**Monks Orchard Residents'
Association
Planning**

18th April 2023

TOWN AND COUNTRY PLANNING ACT 1990
Appeal (W) under Section 78
Location: 44 Orchard Avenue CR0 7NA
LPA Application Ref: 22/02015/FUL
Appeal Ref: APP/L5240/W/22/3309454
Written Representation Close: 1st May 2023

Tracking Analysis Figure 4.2 of the Transport Statement shows the required swept paths for ingress and egress for parking vehicles.

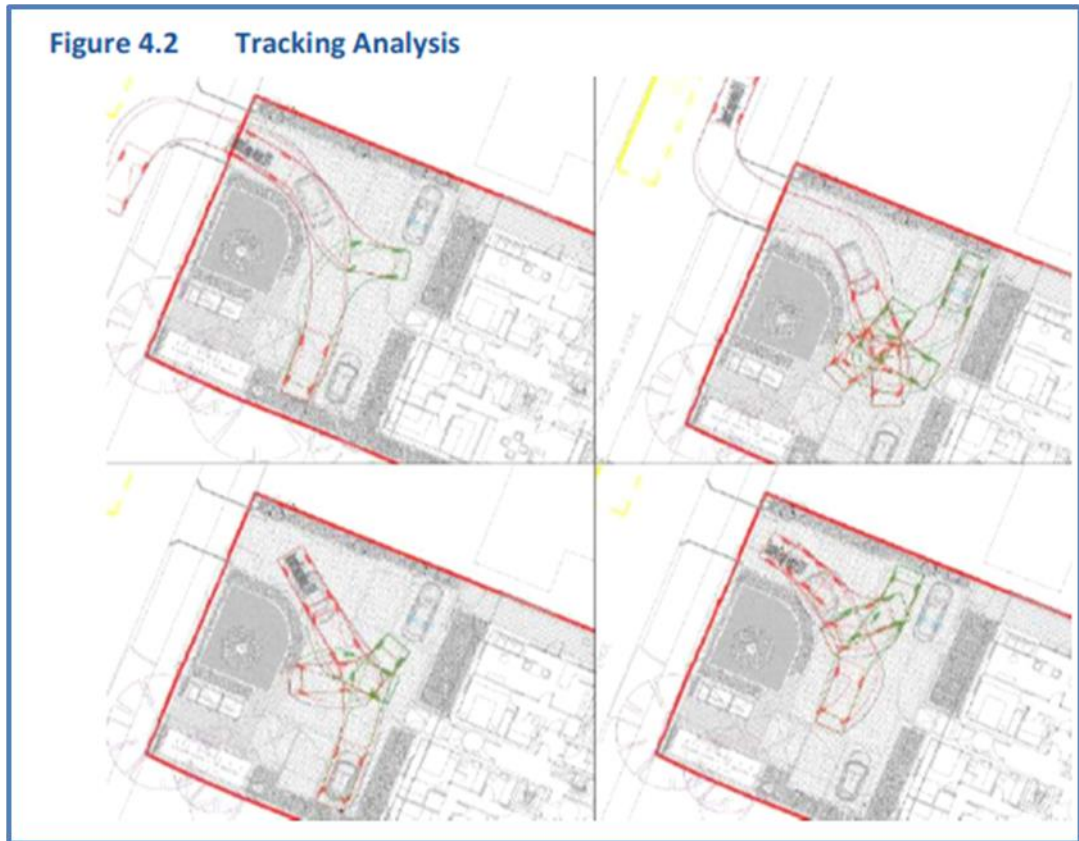
5.2.1 The Transport Statement indicates **Swept Paths** are provided in **Drawing 7040** but there is **no such Drawing available on the Public Access Register**.

5.2.2 The Figure 4.2 is purported to be an extract but is of a very poor-quality reproduction and the full assessment of swept paths movements cannot be analysed or assessed due to the blurred quality of the reproduction. The manoeuvres to enter and exit Bays 3 & 4 seem to be extremely complicated for normal parking and therefore are considered an inappropriate indicator of the parking provision or arrangement for parking for the life of the development. This evidence substantially supports the LPAs Reason 3 for refusal (See below).
